Date: May 28, 2024
Attention: Kimberly Thompson, Natural Resource Specialist, FrontCounter BC
Re: Crown Land Tenure Application (Tracking Number 100439391)
 Land / Foreshore Use Application: Shoreline Erosion Mitigation ("Green Shoring")
 Information Request IR-001

10 **INFORMATION REQUEST RESPONSES**

PROJECT TITLE:
BEACH EROSION PROJECT
2022.68 QUARRY DRIVE

DRAWING NO:
2022.68-46-LAY-006

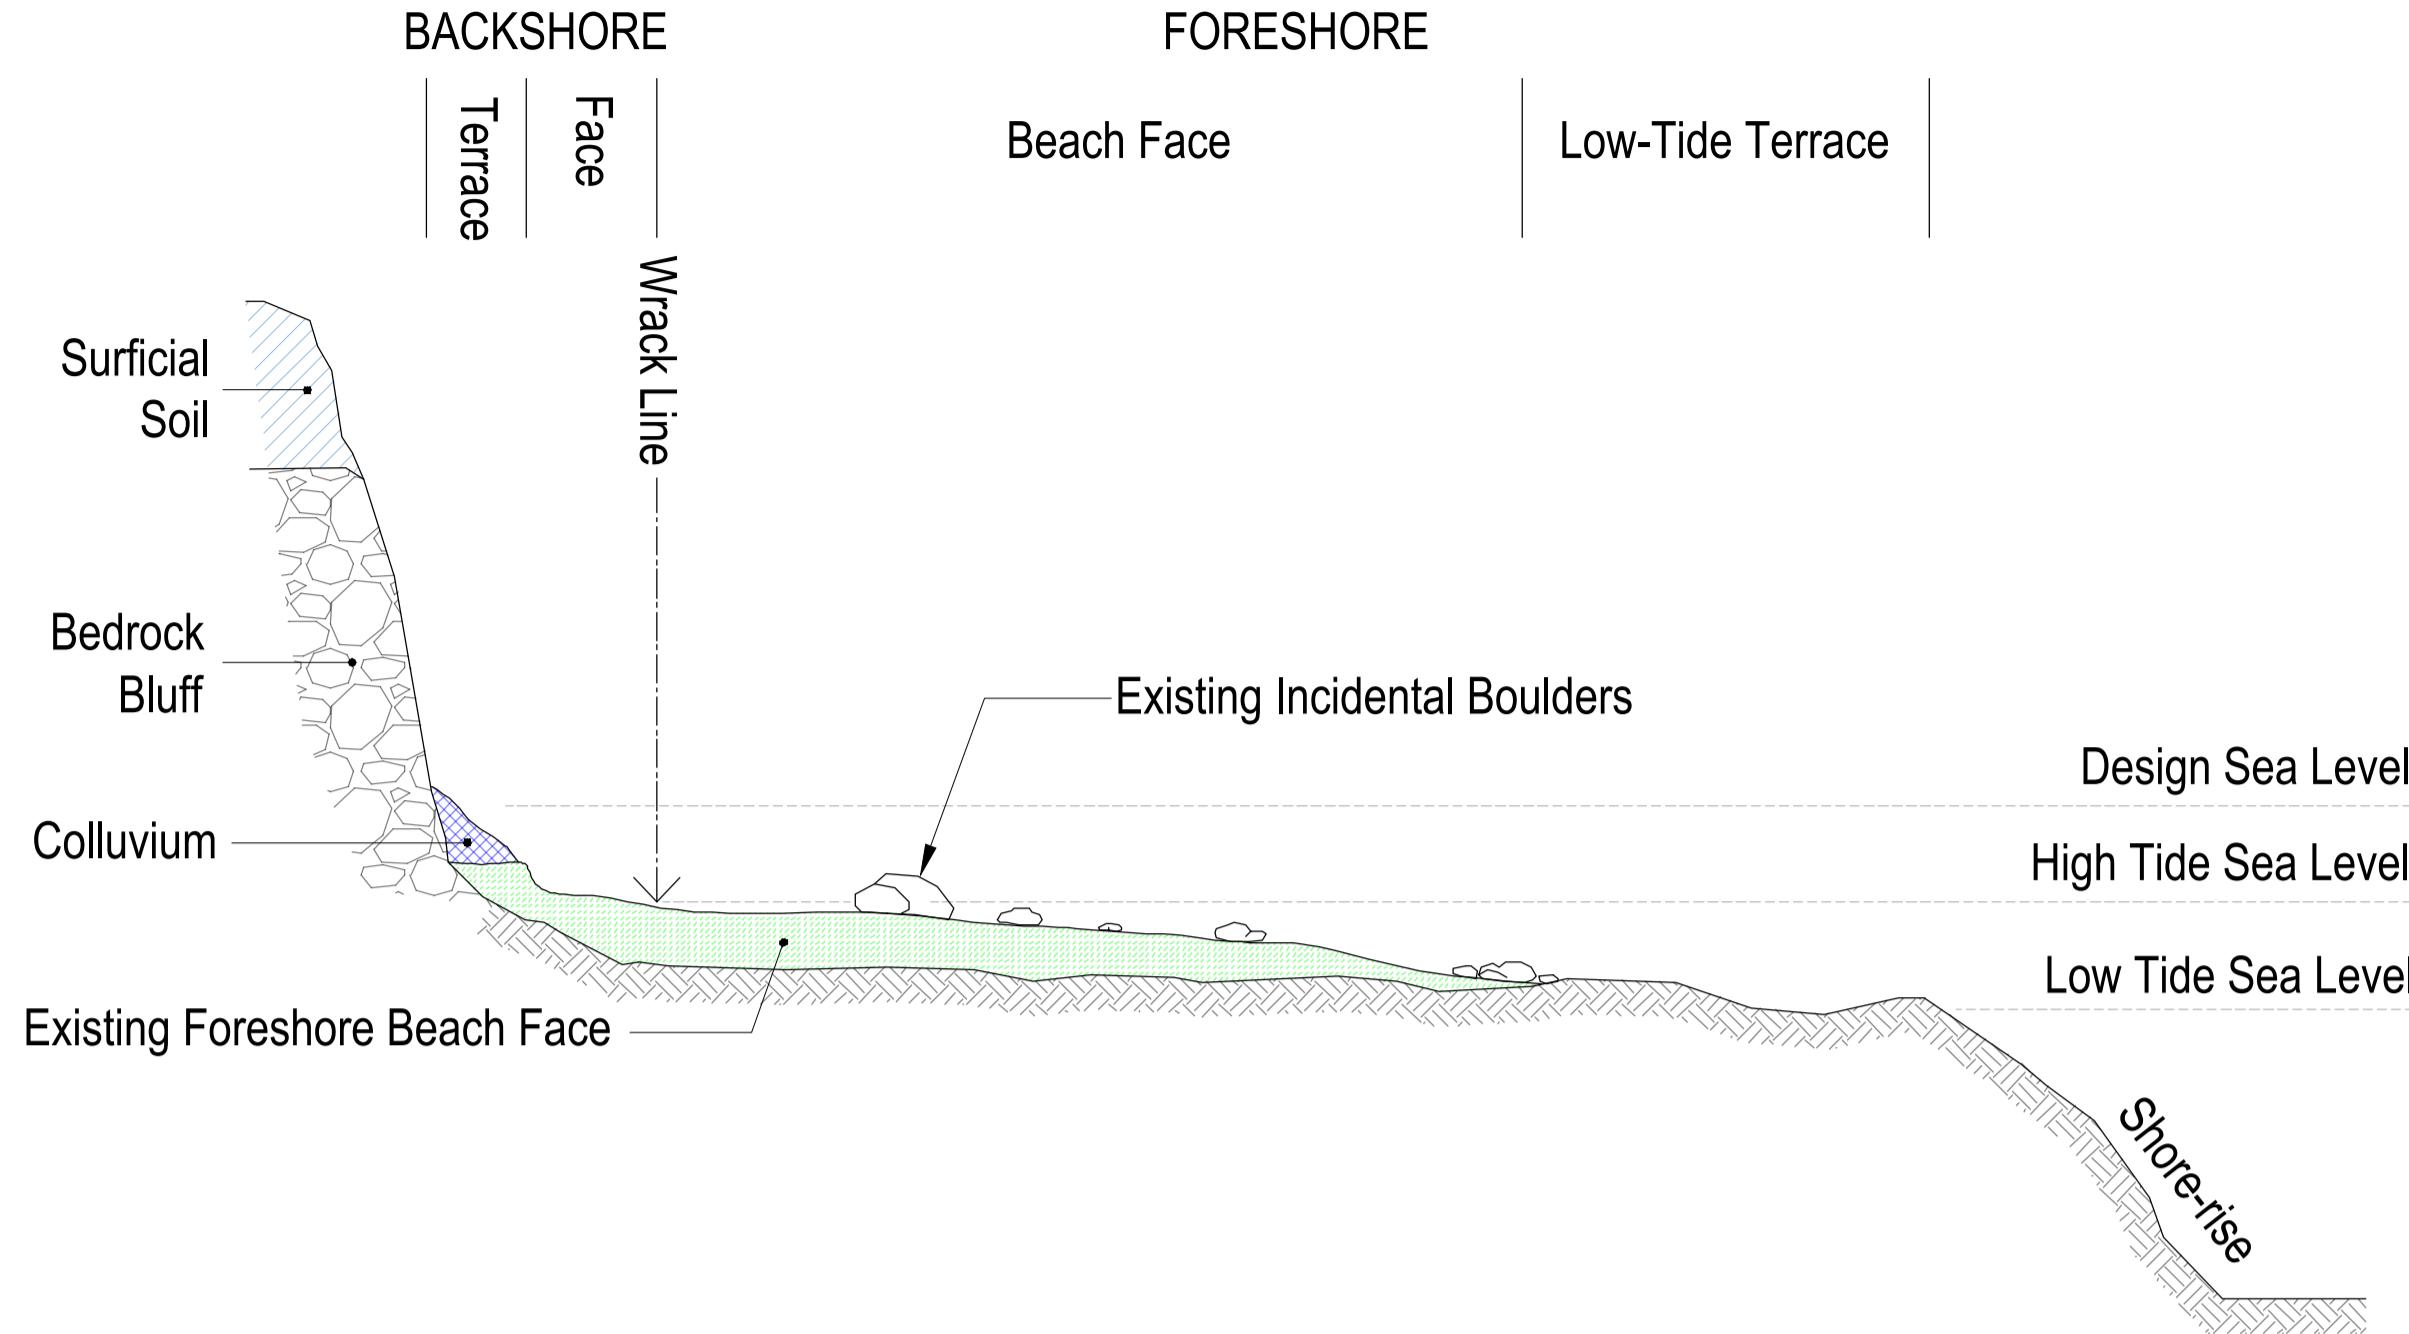
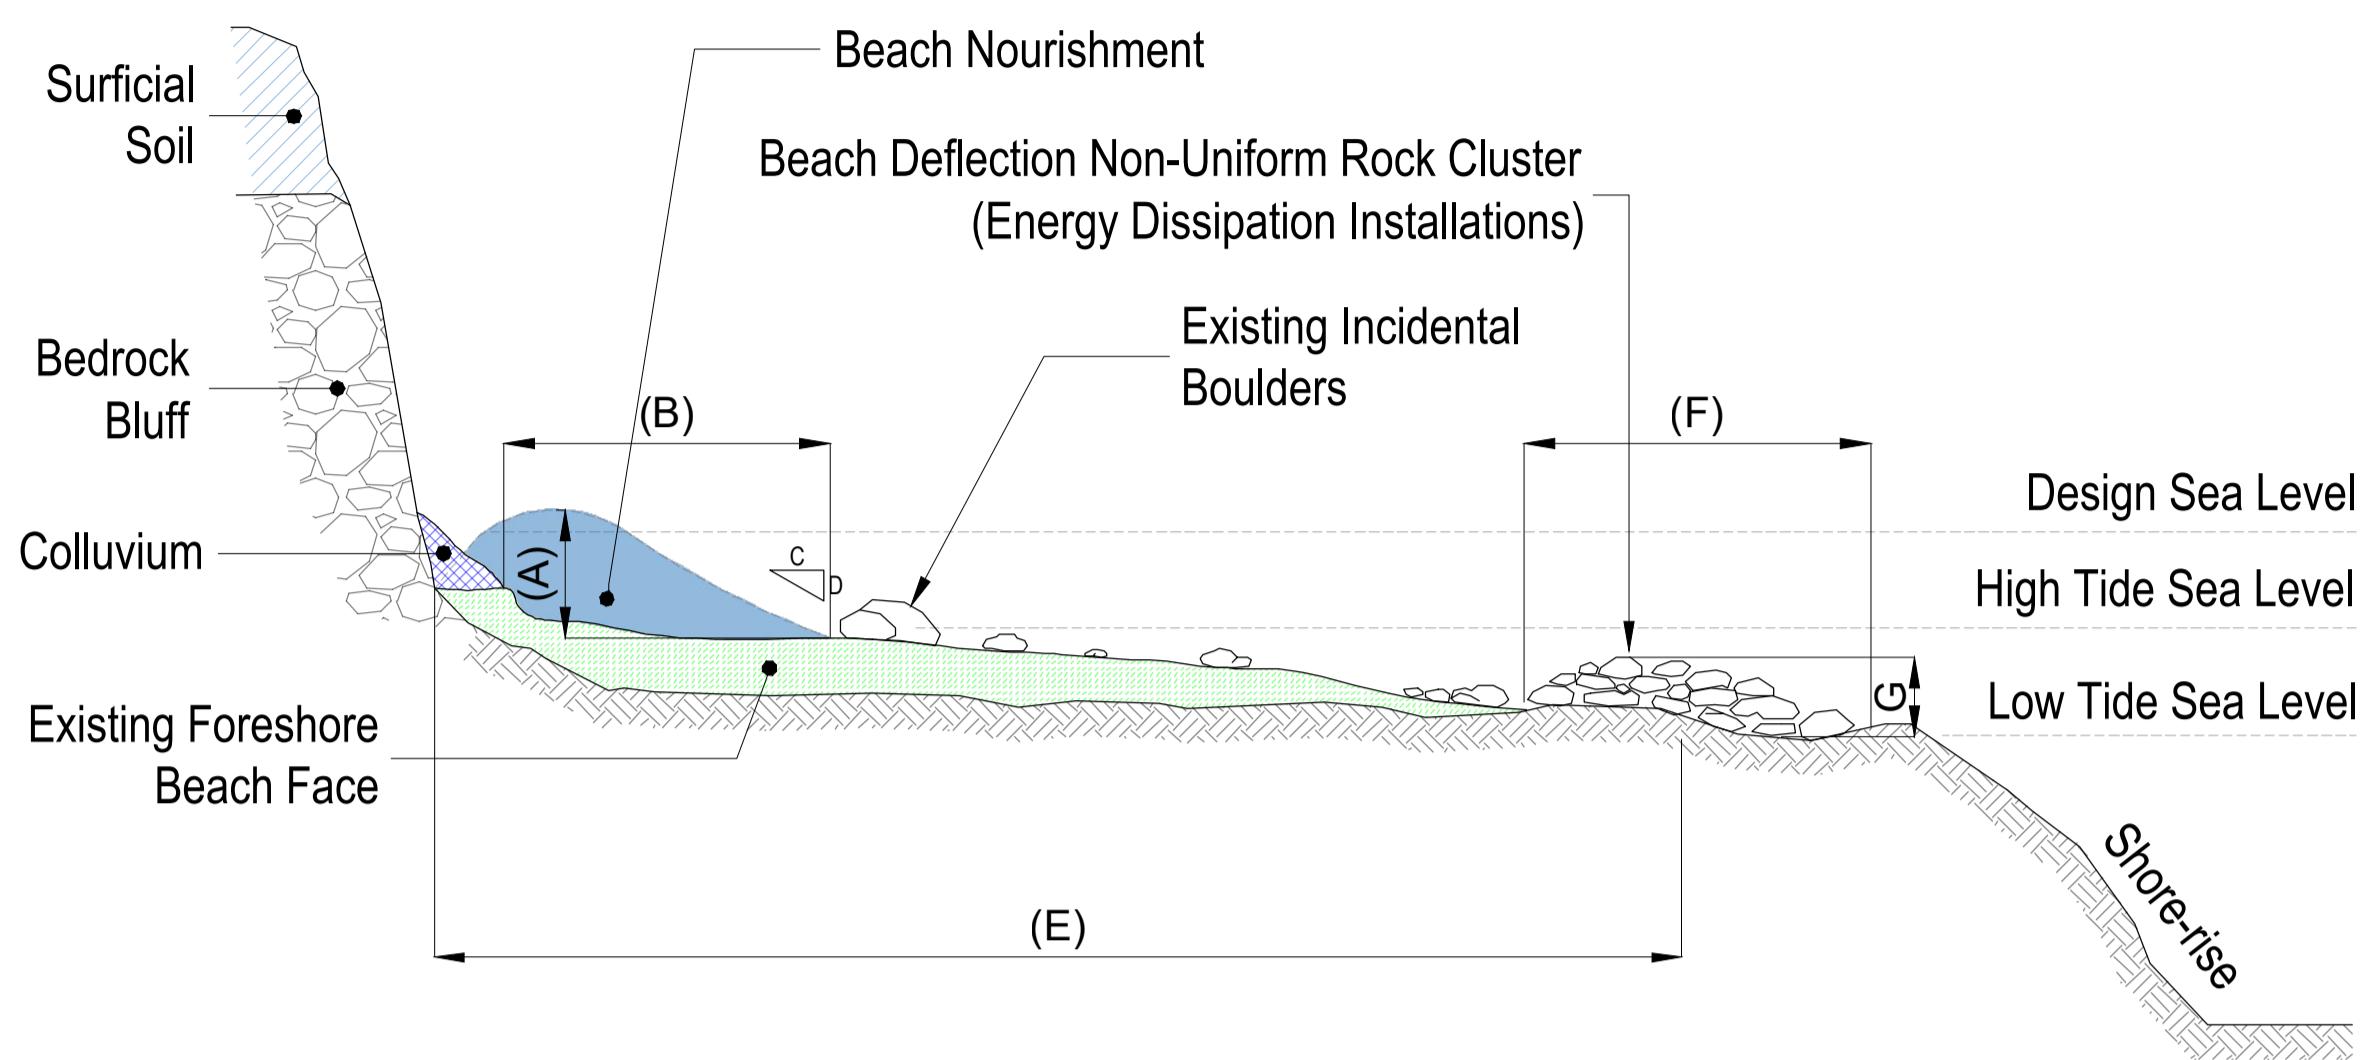
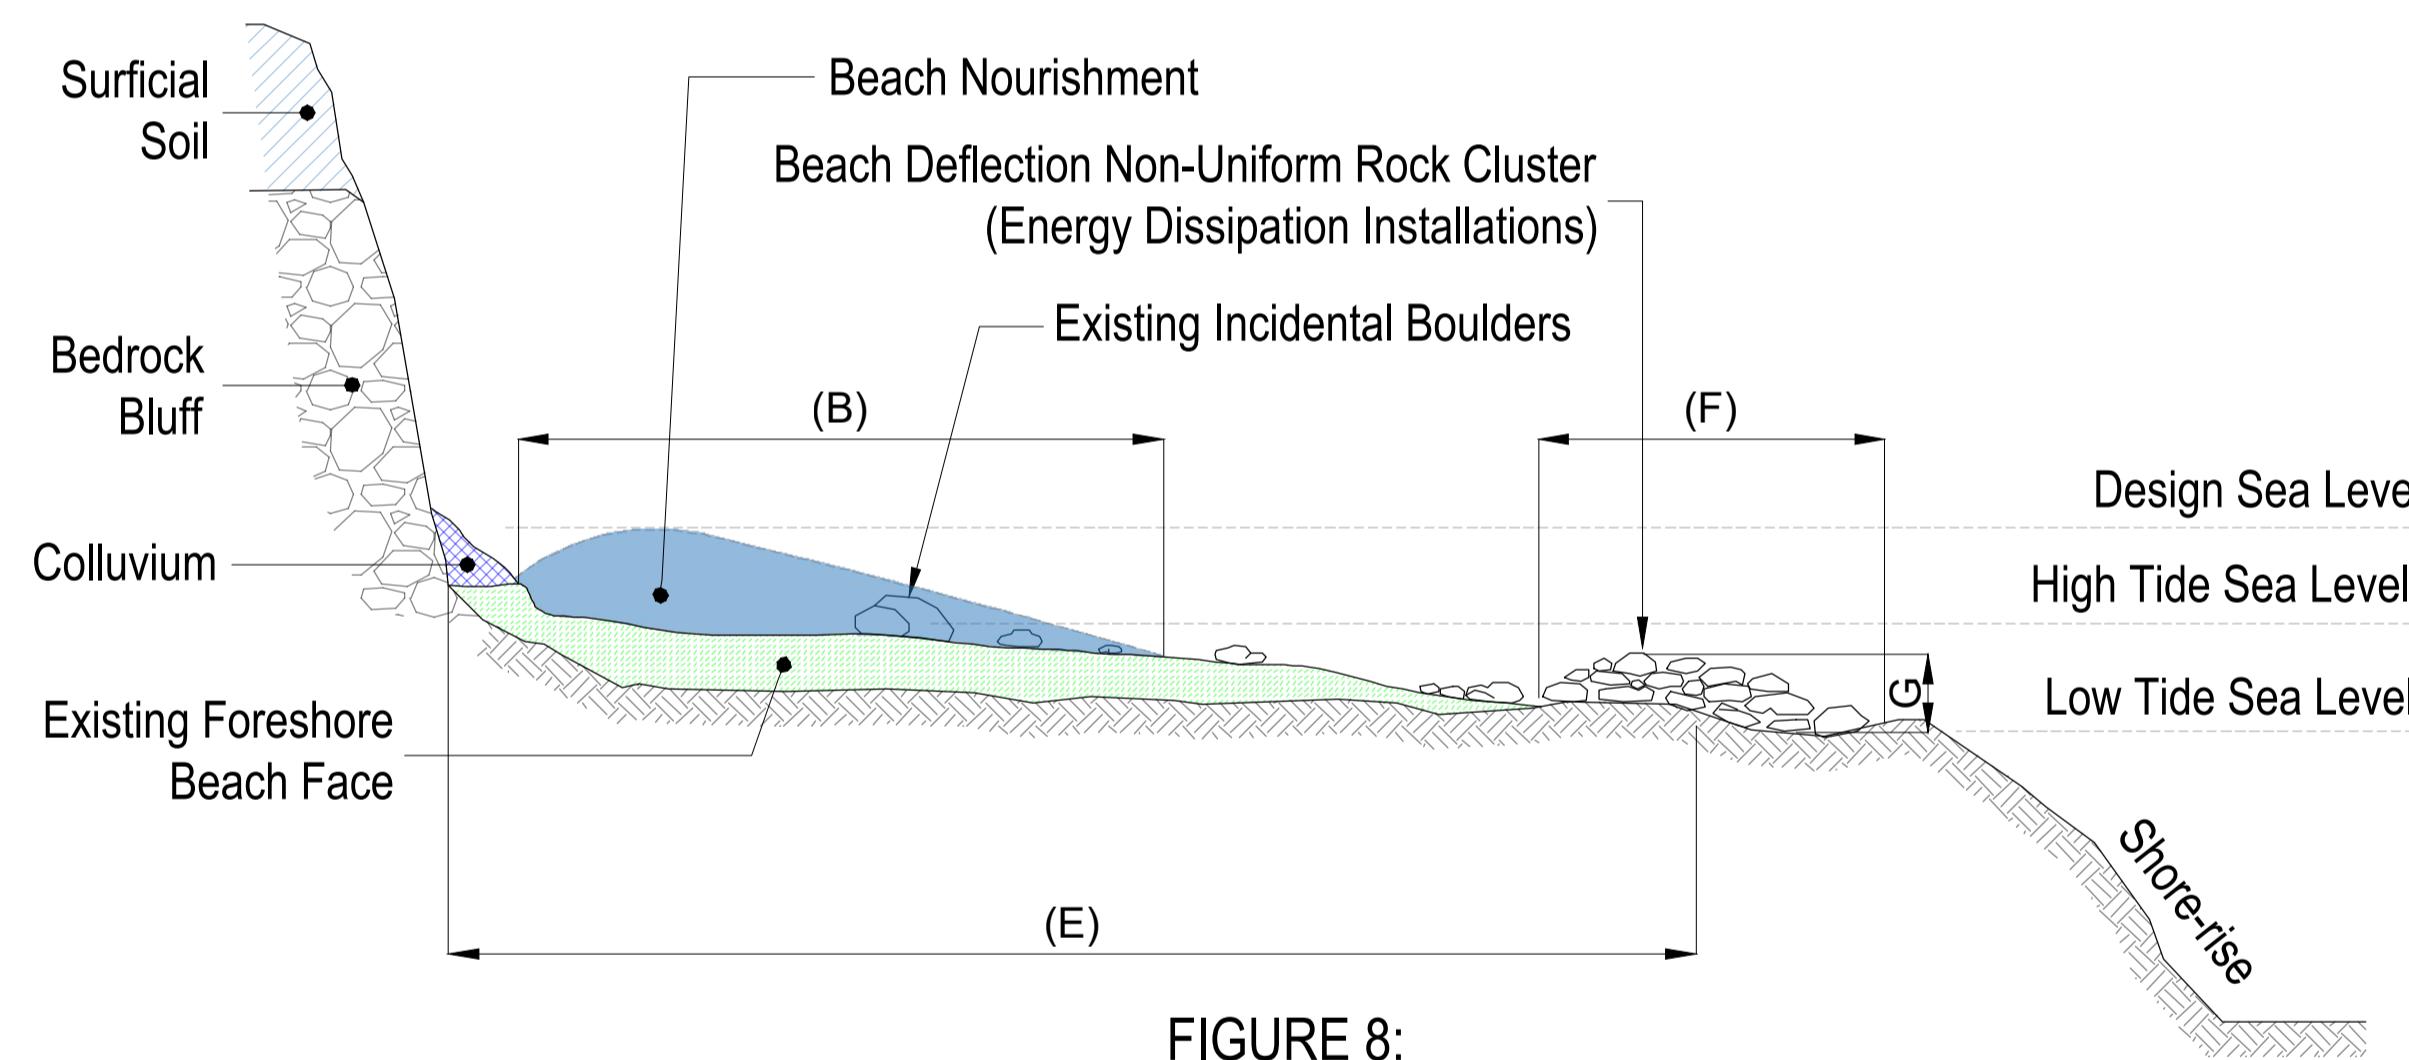
29 04. *Section 3.2 of TRE's "Assessment of Marine Shoreline Characteristics" report recommends sparse
 30 placement of boulders in the indicated areas to deflect waves. However, the side view plan in the
 31 drawing package shows non-uniform rock clusters. Please update the application package to
 32 provide more information about the boulders or rock clusters such as the size range of the rocks,
 33 approximate size of each cluster, approximate number of clusters and approximate spacing
 34 between clusters.*

- 43 • Response IR-001.04.2 (GEO, TRE): Cluster Specification
- 44 i. 0.5 – 1.2m boulders, sandstone or low sulphide granite, rounded to sub-rounded
45 (no blast rock)
- 46 ii. Amoebic clusters of 10 – 15, generally with 20% density within the areas
47 designated on the plans.
- 48 iii. Spaced 0.5 – 1.0m
- 49 iv. -Placed on the largest side to minimize topple/movement
- 50 • Response IR-001.04.3 (ENG): Drawings have been updated to include further "wave
51 energy dissipation installations" terminology.
